TOWN OF YARMOUTH
200 Main Street, Yarmouth, Maine 04096
www.yarmouth.me.us

Planning Board Report
Railroad Square Master Plan
Concept Plans for Development Plan & Major Subdivision
Railroad Square Associates, LLC, Applicant
Map 37 Lots 28 and 29A; CD-4 Village Center Character District
Prepared by Erin Zwirko, Director of Planning and Development
Report Date: March 17, 2022; Planning Board Date: March 23, 2022

ILLUSTRATION 6.D STANDARD PEDESTRIAN SHED

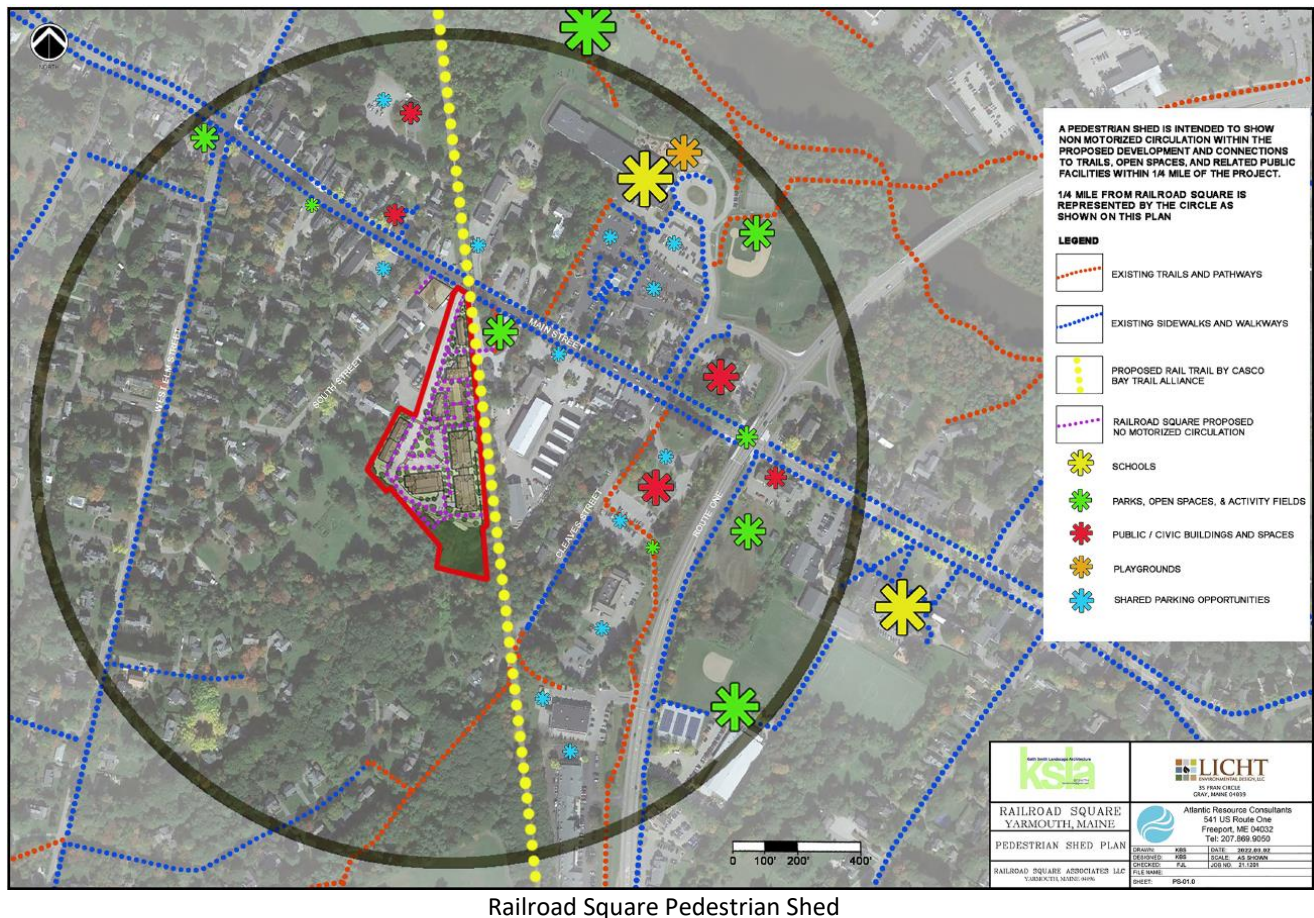
A Pedestrian Shed illustration was discussed at the March 9, 2022 meeting. The applicant wrote, “This plan provides a context of all trails and walkways – existing and proposed, open spaces and civic buildings within ¼ mile of the project. What can be identified from the plan is that the RRSQ neighborhood is both centrally located adjacent to existing sidewalks and the proposed rail-trail and is directly or indirectly linked to the Town Hall, Library, William Rowe School and the Village Green to name a few locations. This plan demonstrates again, the strength of Railroad Square as a walkable-bikeable neighborhood located in the heart of Yarmouth Village.” The following is the applicant’s Pedestrian Shed illustration.

The staff agreed with the applicant’s assessment and find the Pedestrian Shed illustration to be adequate, although may be missing some Common Destinations in the Village. Those locations that may be missing is the NYA Campus, the Route One bridge, the Log Cabin, trails within Royal River Park, 317 Main Music Center, the Community Center at the Masonic Hall, the Old Meeting House, the Center Street Island, and the Butterfly Park and Beth Condon Memorial. The Village is the heart of the community, and the proposed development will be well-connected to the existing network for pedestrians and bicyclists to access the Common Destinations present in the Village.

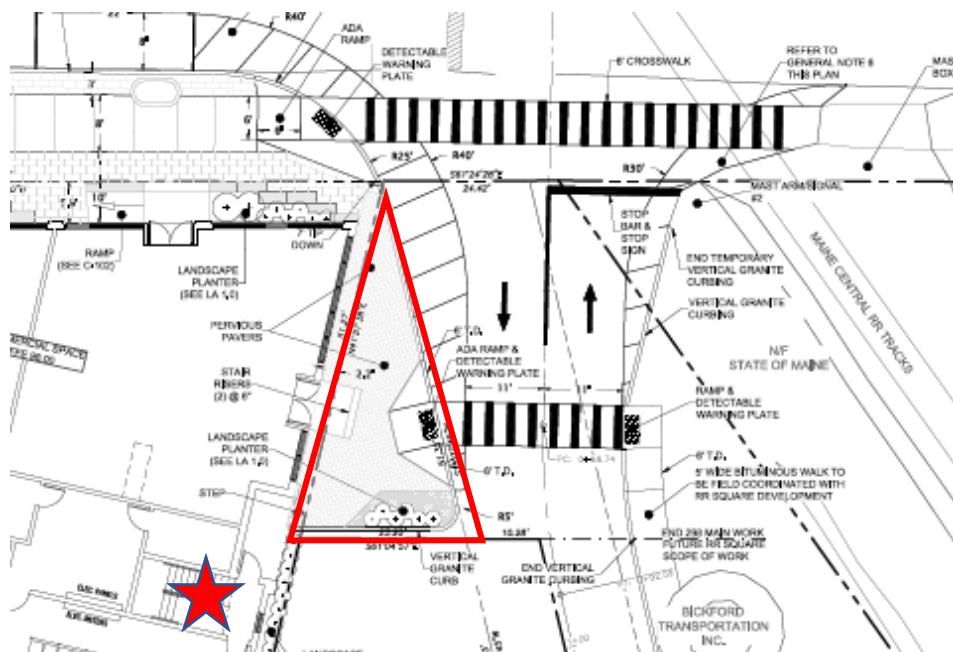
Thoroughfare TF-1: The Road Thoroughfare is technically not a Thoroughfare option for the CD-4 District, where Railroad Square is located, as only SD-1 appears in the heading of Table 6.E.2B (see the illustration above). However, it is likely the best fit for this existing condition at the intersection of Railroad Square and Main Street and for the first 120 feet of the access into Railroad Square. The condition is along the shared easement with Down East Energy, two 11-foot shared travel lanes, and one 6-foot sidewalk is proposed. No parking is proposed on either side of the roadway. No planter type (E in the illustration above) is provided, although the existing conditions on both sides (Down East Energy and the pavillion) likely make this difficult to comply with this standard. No information on the turning radius is provided either.

As noted elsewhere in this report, the condition along Down East Energy needs more thought to ensure that appropriate delineation and control/management of movements is provided. As noted by the peer reviewer, *“Otherwise the roadway appearance may promote higher speeds and vehicle turn conflicts (similar to a wide open parking lot without delineation).”* The Bike and Pedestrian Committee notes that the radius at Main Street is quite large and should be minimized with curb bump outs and a raised crossing, to the extent that it would be feasible due to the size of Down East Energy vehicles as well as service vehicles accessing the commercial or residential buildings in Railroad Square. As noted in the introduction, the Department of Planning & Development and other Town staff will focus on this intersection and the relationship to the upcoming Phase 2 of the Main Street streetscape project.

Approved 298 Main Street Site Plan (Residential Entrance/Exit shown with the star, patio outlined in red)

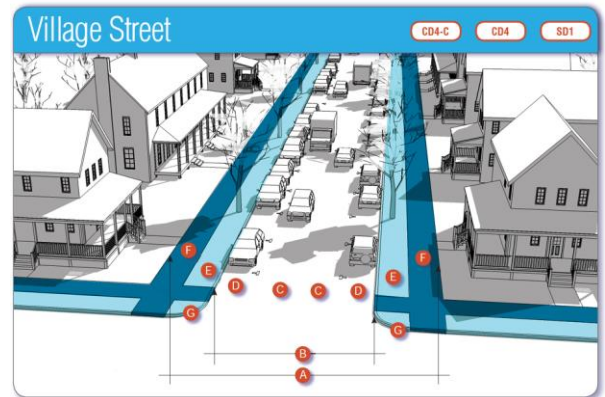
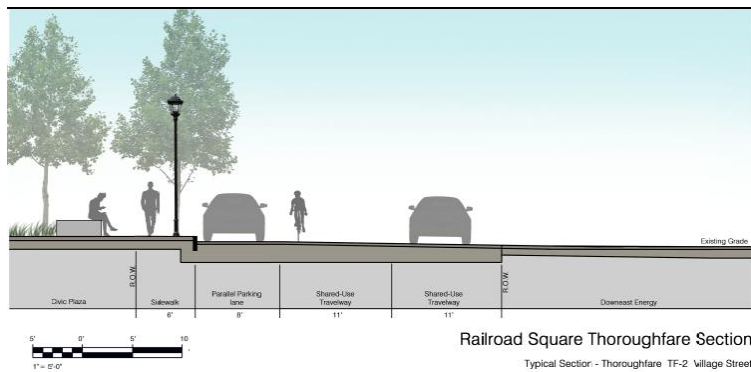
In addition, residents leaving 298 Main Street will have some shelter upon leaving the residential entrance as a curbed patio is proposed along the edge of the building with a second crosswalk accessing the sidewalk along TF-1 as shown in the screenshot of the approved 298 Main Street plan below.

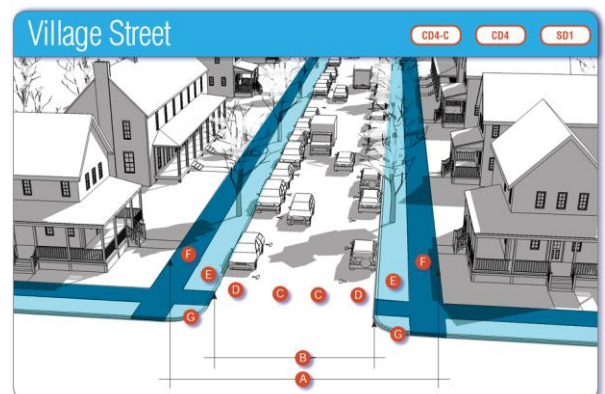
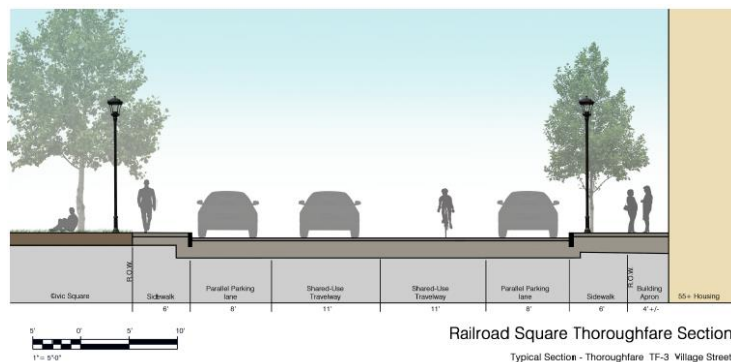
Thoroughfare TF-2: The Village Street is a Thoroughfare type allowed in the CD-4 District. The section provided in the application materials meet the requirements for a Village Street as outlined in Table 6.E.2F, including for the type, assesmby, planter, and walkway. The curb radius is not provided for assessment.

The Town's peer reviewer noted that the 6-foot sidewalk may not be sufficient given the sidewalk amenities illustrated in the section, but in the areas where the Civic Plaza abuts the sidewalk there is likely sufficient space. This is an example where more detailed drawings of the Public Frontages are necessary to understand whether the sidewalk will be too constrained with the amenities called for by the CBDC. Parallel parking is proposed and is an allowed element in the Village Street Thoroughfare, although it should be noted as called out by the Bike and Pedestrian Committee that occupied parallel parking slows traffic only when it is occupied. The Committee suggests that there may be a better use for this area by occupying it with plantings, benches, bike racks, public art, and other amenities. The Planning Board will note that the applicant must balance providing adequate parking for the uses proposed, including on-street parking, and providing public amenities within the Public Frontages.

As shown on the illustrative site plan, the TF-2 includes curb extensions at the Passage C and where TF-2, TF-3, and TF-4 meet. Comments that have been received suggest that where TF-2, TF-3, and TF-4 meet, a raised table should be utilized to draw attention to merging motorized, pedestrian, and bicyclist traffic. The applicant should provide additional details on how pedestrian traffic will be prioritized in this location as required by one of the other Thoroughfare standards.

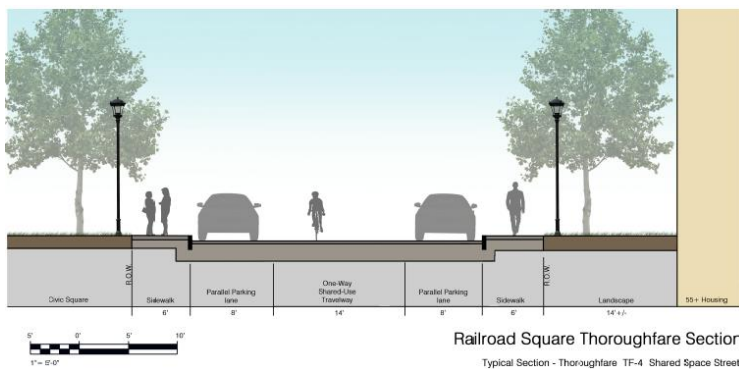
Thoroughfare TF-3: TF-3 also utilizes the Village Street, a Thoroughfare type allowed in the CD-4 District. The section provided in the application materials meet the requirements for a Village Street as outlined in Table 6.E.2F, including for the type, assesmby, planter, and walkway. The curb radius is not provided for assessment.

TF-3 spans the area between the Civic Square and the six carriage house units on Lot 6 and Lot 7. It also intersects with the driveway to the underground parking serving Lot 4 and Lot 5 as well as the TF-4 Shared Space Street on the opposite side of the Civic Square. The Town's peer reviewer suggested that the 6-foot sidewalk width on the west side may not be sufficient given the Public Frontage amenities, but with the additional 4-foot building apron it should be

The Planning Board previously discussed how the rear of Railroad Square becomes primarily residential and private. At the intersection with the driveway to the underground parking, the transition from public to private is more stark as it only provides access to private parking. The Planning Board and applicant may want to consider a specific treatment at this intersection that suggests this transition and avoids the general public from needing to make k-turns to turn around as presumably the garage entrances will be secured. It could be narrowing the driveway access more substantially to make it uncomfortable to access or simply include signage. It may also make the very last on-street parking space unusable.

At the transition to TF-4, a change in the pavement, a change in canopy with street trees proposed on both sides of the Thoroughfare, and the Public Frontage amenities should suggest to motorized and nonmotorized traffic that there is a distinct residential appearance. Raised pedestrian crossings may be appropriate at this intersection as well.

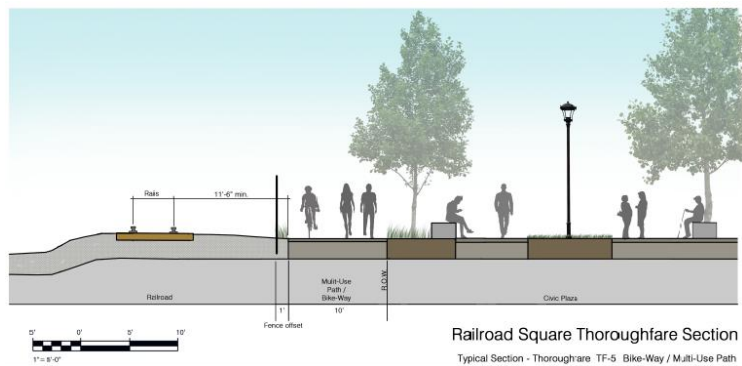
Thoroughfare TF-4: TF-4 utilizes the Shared Space Street, another Thoroughfare type allowed in the CD-4 District. The section provided in the application materials meet the requirements for a Shared Space Street as outlined in Table 6.E.2F, including for the type, assembly, planter, and walkway. The one-way condition is not necessarily envisioned in the CBDC but supports the intention of the Thoroughfare type. Also note that the sidewalk is curbed, so it does not provide exactly the freeflowing motorized and nonmotorized traffic envisioned for a Shared Space Street (see the illustration above) since the sidewalk is still separated from the travel and parking lanes. The Planning Board discussed how a change in pavement type could be beneficial to TF-4.

However, the Fire Department has indicated that there needs to be 20 feet of obstructed width per the NFPA regulations. As proposed, the one-way shared use travelway is proposed at 14 feet with two parking lanes of 8 feet each. The applicant will need to resolve this discrepancy to the Fire Chief's approval.

At the intersection of TF-4, TF-3, TF-2, and the parking area on Lot 3, there is concern about conflicts between motorized and nonmotorized traffic. One of the other Thoroughfare standards suggests in cases where there may be conflicts, the pedestrian access should be prioritized. A large raised table has been suggested, but the applicant should provide more details on how they will accomplish providing a safe intersection that prioritizes pedestrian traffic over motorized traffic.

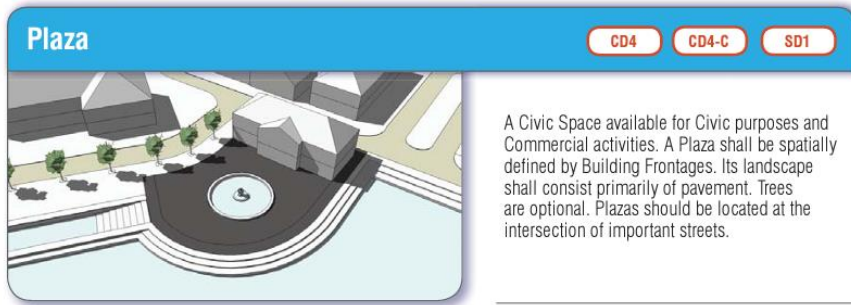
The Open Space area is designated as H on the Development Plan, and the applicant has indicated that it will feature a trail connection for passive recreation:
